Request For Information

Project Name: Replace Roofs (Program Phase 1 - 4)

Title: Roof Replacement - Phase 1 Facility B

RFI#: 008

9 EXHAUST FAN CURB

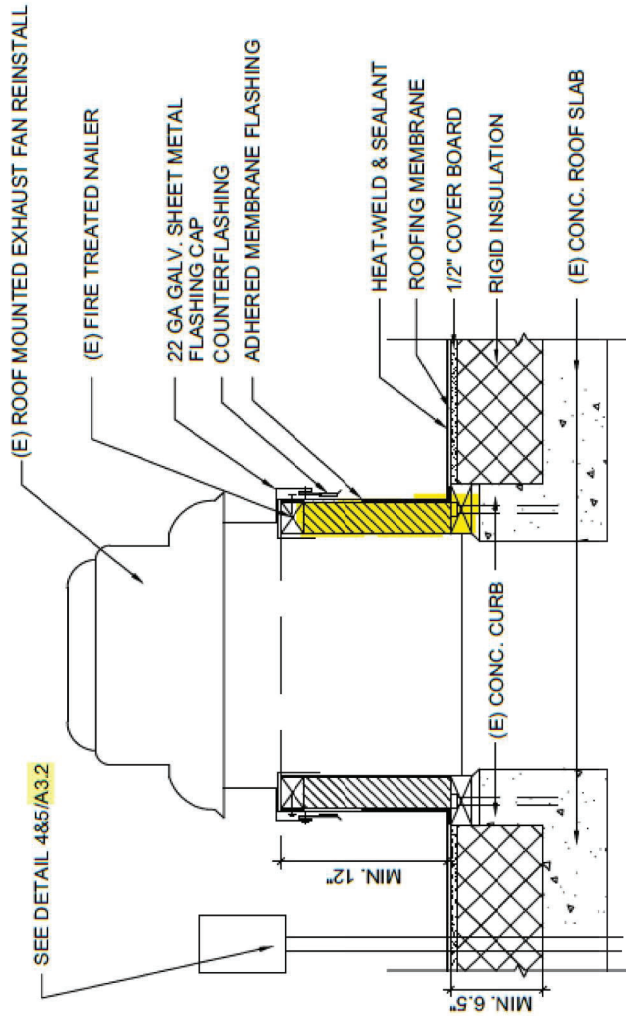
CCM is requesting clarification of material for new curb extensions. See Attached Plan Pg. Det-9 A3.4. CCM Request to use Steel Stud framing 3-5/8" 16 Gauge top and bottom track. Bottom track installed with 1/4" x 2" Simpson strong tie concrete anchor bolts (3 per side). Attached 1/2" dens deck to both side of frame and up to exhaust fan curb above minimum height requirements in lieu of curb extensions. CCM request to remove fire treated lumber that exhaust fans currently rest on and replace with Steel Stud framing. This would be more cost efficient and eliminate the need for fire treated lumber and a similiar approved RFI 006 for project I-001104 LAC see attached. Is this acceptable please advise.

I have requested that the consultant revise their detail to specify the type of curb extension they require. the possibilities include premade curb extension or field constructed. Your suggestion of a field constructed curb extension appears acceptable but the consultant will provide an updated detail. Once we have the corrected detail for the curb extension, it will be issued in a forthcoming CB.
